**Proposed Amendments to the Jersey Avenue Park Redevelopment Plan
Emerson District**

February 1, 2017

COLES STREET TYPICAL ROADWAY SECTION
FACING NORTH

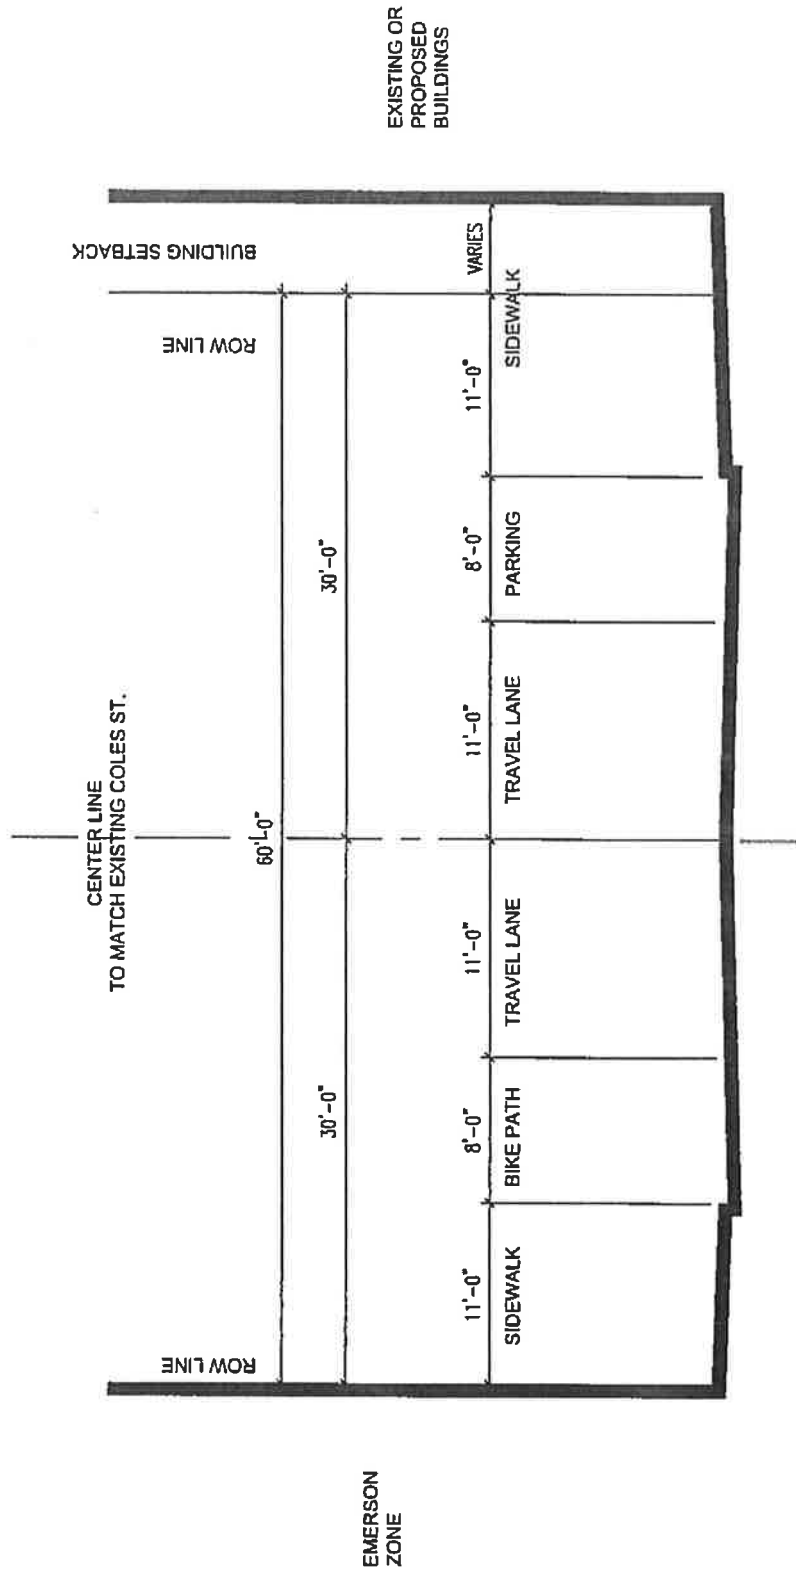
M. *Fifteenth Street will be re-opened between Coles Street and Monmouth Street as part of the redevelopment of the Emerson District. Typical Cross Sections for Fifteenth Street and Coles Street are included within this Redevelopment Plan.*

**60' TO 70' WIDE MONMOUTH STREET PREFERRED ROADWAY
SECTION BETWEEN 14TH STREET & 16TH STREET
FACING SOUTH**

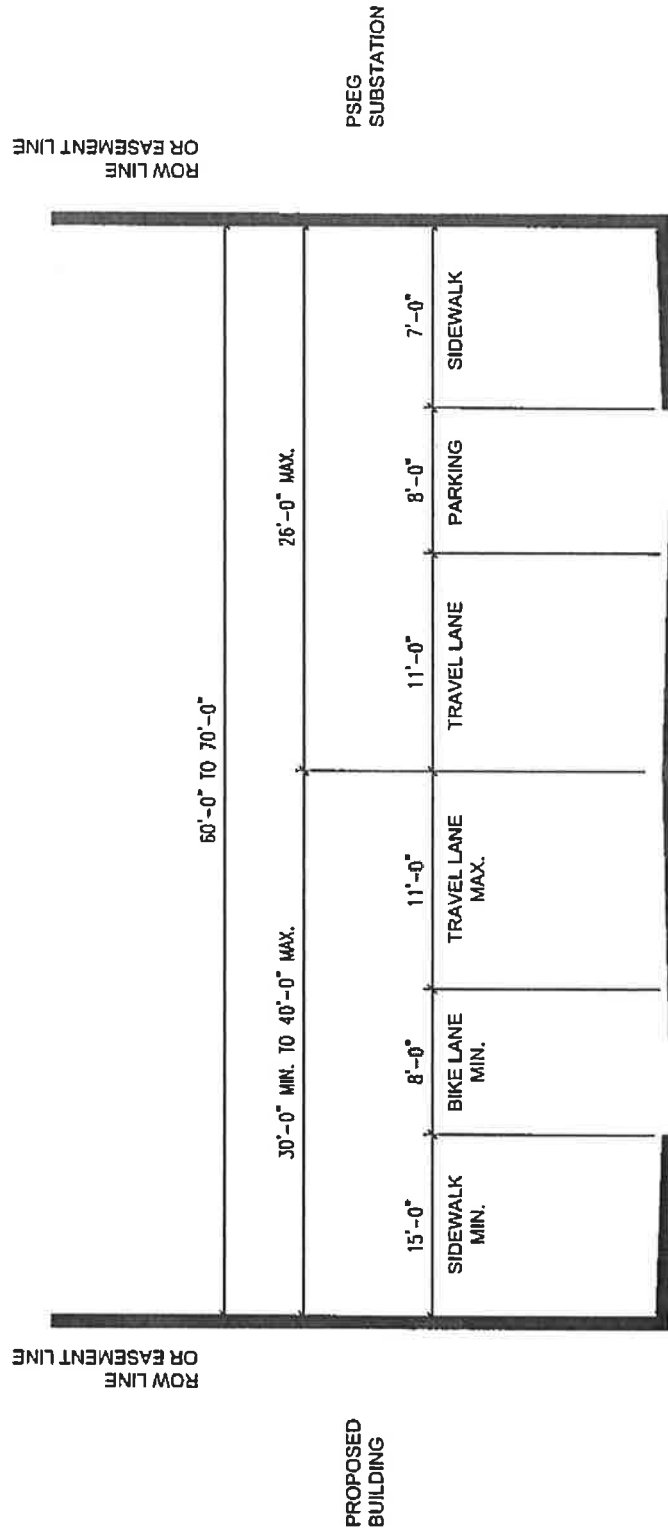
J. Open Monmouth Street to extend from Thirteenth Street to Hoboken Avenue with a right-of-way width of 60-70 feet. The City shall work with the property owners adjacent to Monmouth Street north of Thirteenth Street to accomplish the reopening of any portions of the roadway that were previously vacated. Typical Cross Sections for Monmouth Street are included within this Redevelopment Plan illustrating the full 60-70 foot wide right-of-way shall be constructed as determined by the planning board.
